SETTLEMENT AGREEMENT EXHIBIT D PART 5

900 Level Accessible Route of Travel and Accessible Signage

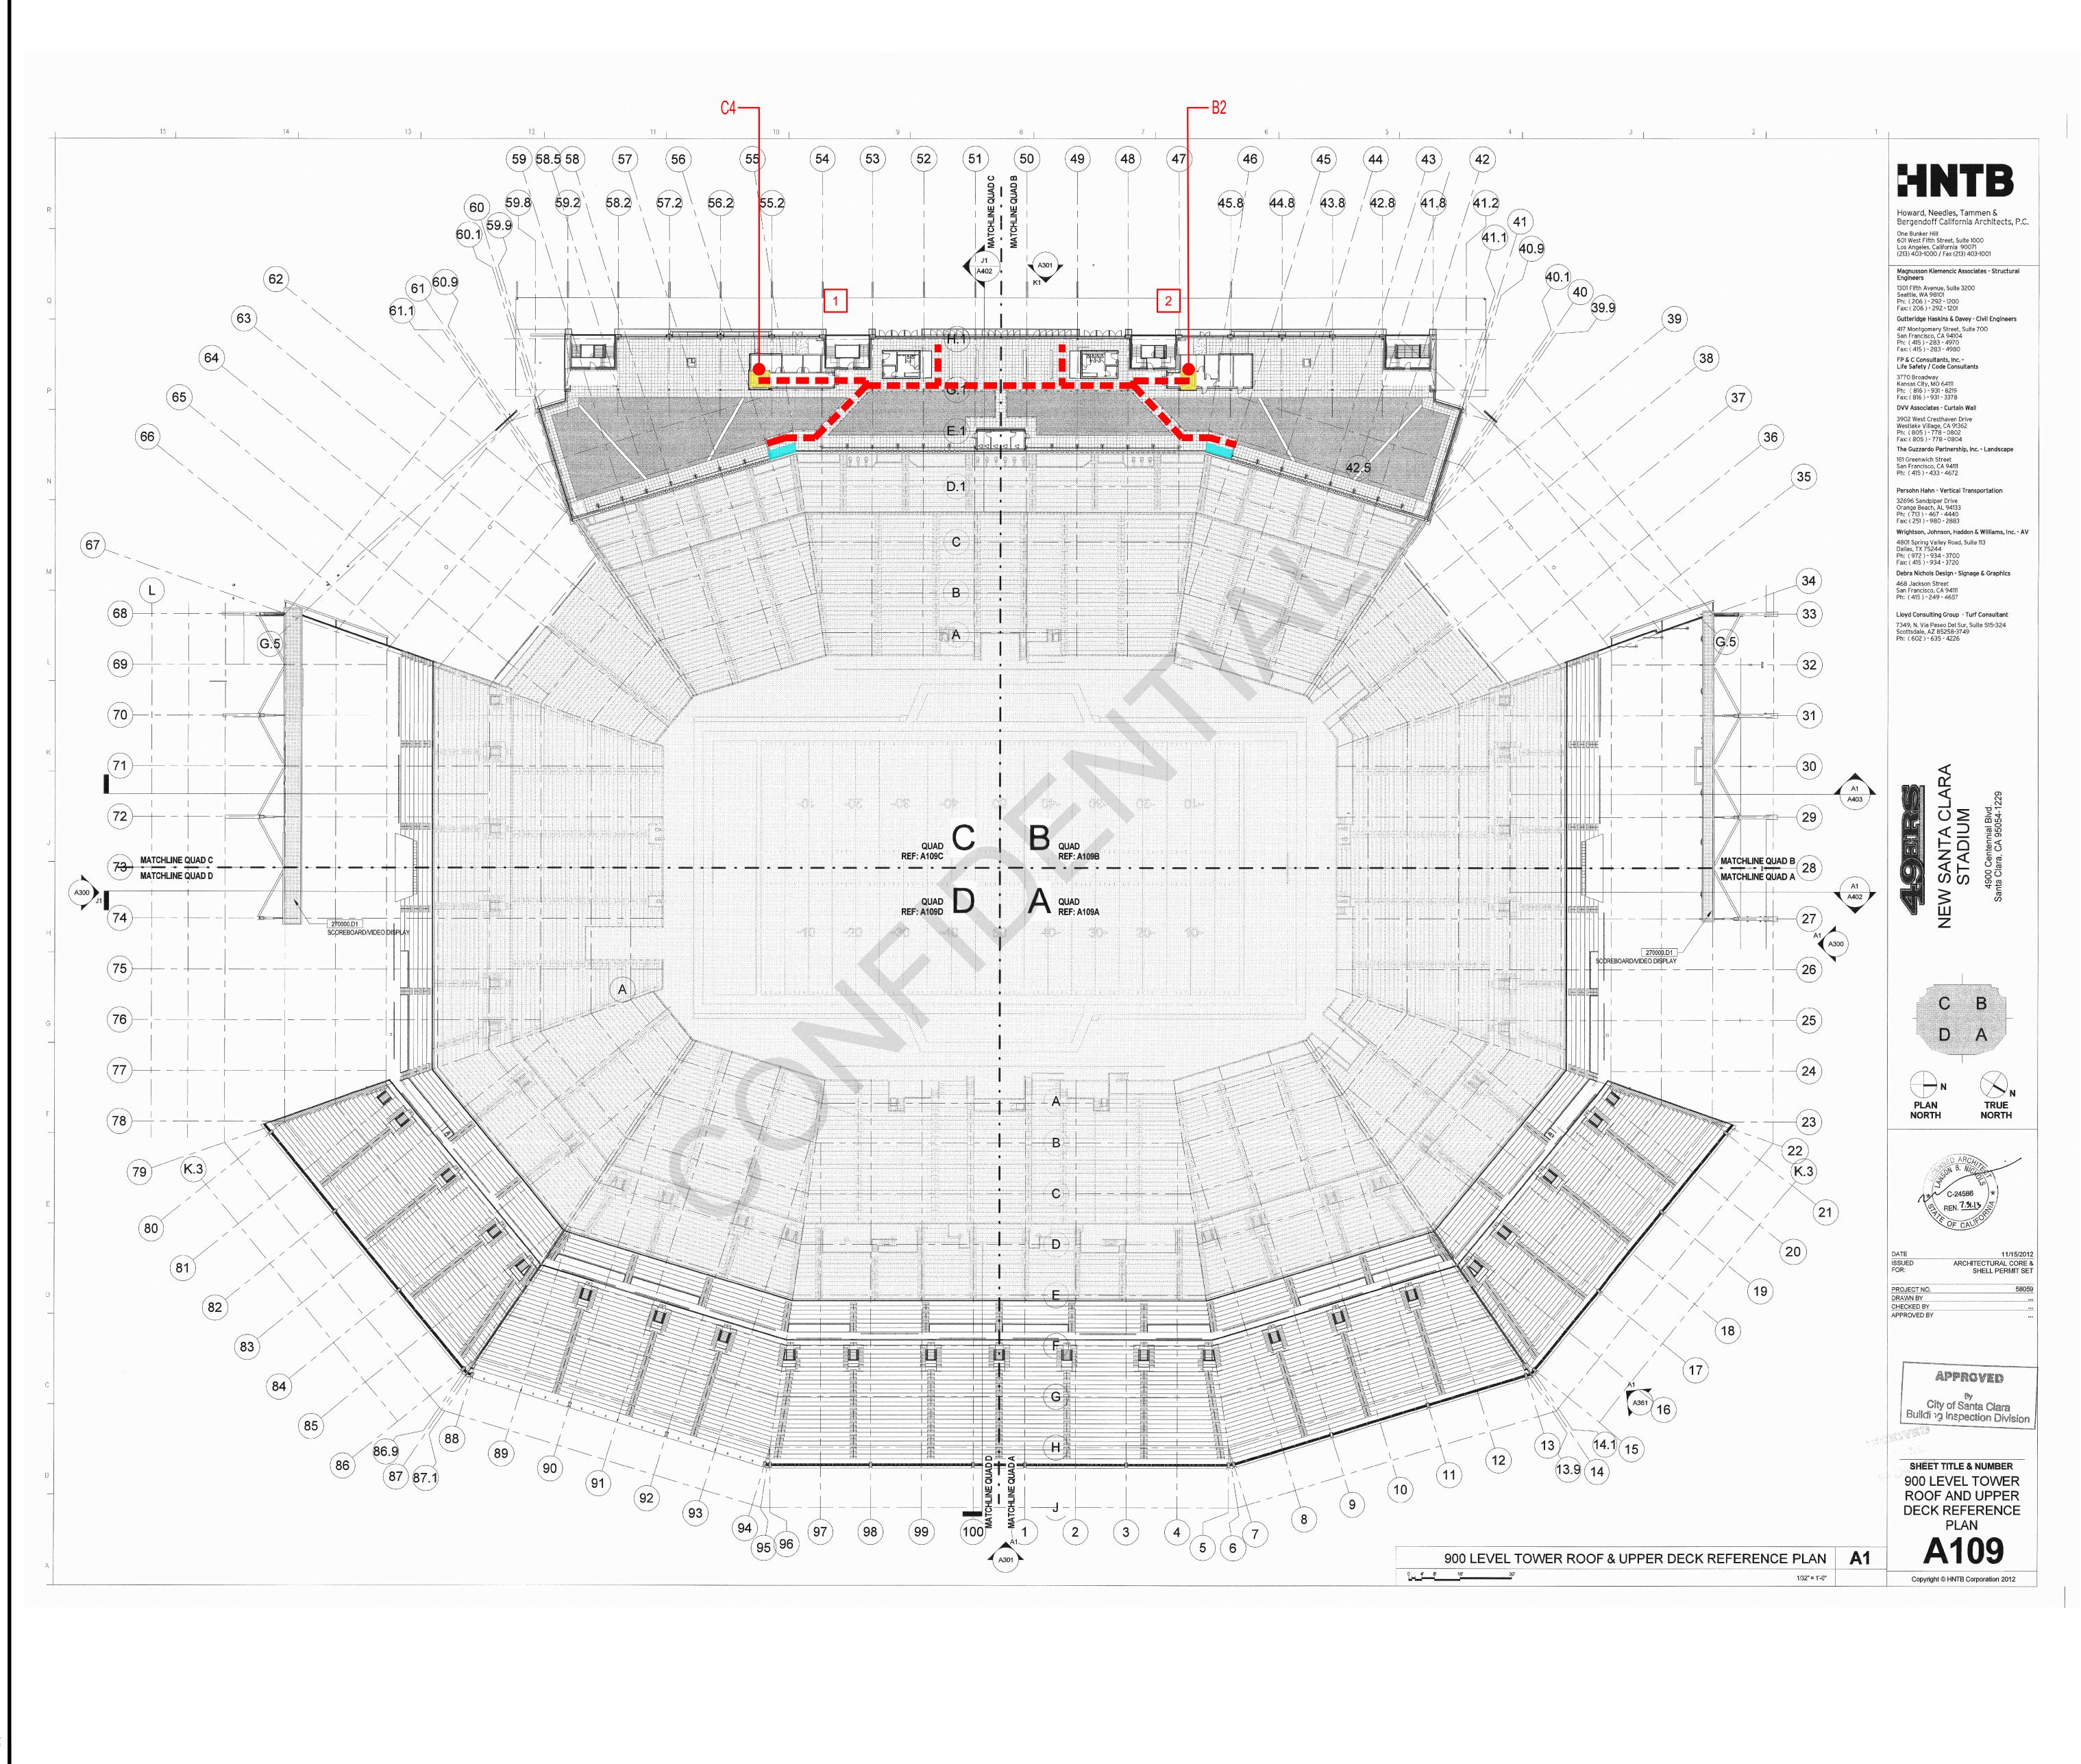
1 AT THE DOOR TO THE LOBBY OF ELEVATOR C4 PROVIDE SIGNAGE AT A LOCATION CLEARLY VISIBLE TO PERSONS WITH DISABILITIES USING A WHEELCHAIR INDICATING THE LOCATION OF THE ELEVATOR. AT THE ELEVATOR PROVIDE SIGNAGE INDICATING THE STADIUM LEVELS IT SERVES.

AT THE DOOR TO THE LOBBY OF ELEVATOR B2 PROVIDE SIGNAGE AT A LOCATION CLEARLY VISIBLE TO PERSONS WITH DISABILITIES USING A WHEELCHAIR INDICATING THE LOCATION OF THE ELEVATOR. AT THE ELEVATOR PROVIDE SIGNAGE INDICATING THE STADIUM LEVELS IT SERVES.
